■ ENGINE PROPER

1. Cylinder Head

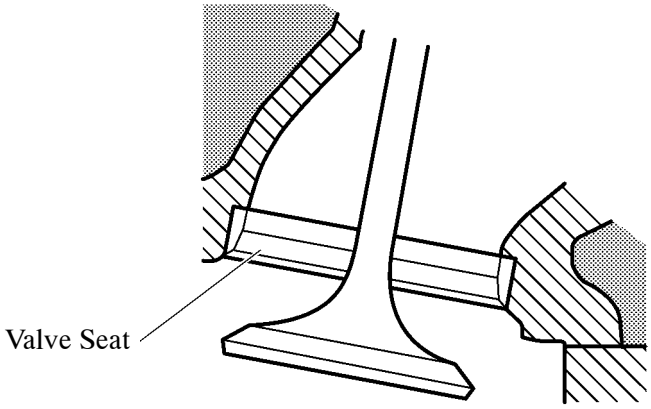
The material of the valve seat has been changed. High wear-resistant sintered alloy is used for the valve seat to be compatible with alcohol fuel.

2. Piston

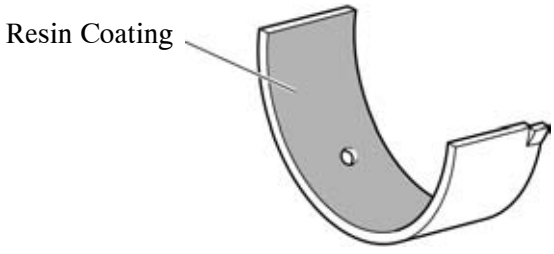
- Compression ratio has been increased for compatibility with alcohol fuel, thus optimizing the shape of the piston.
- A PVD (Physical Vapor Deposition) coating has been applied on the outer surface of the No. 1 compression ring and oil ring.
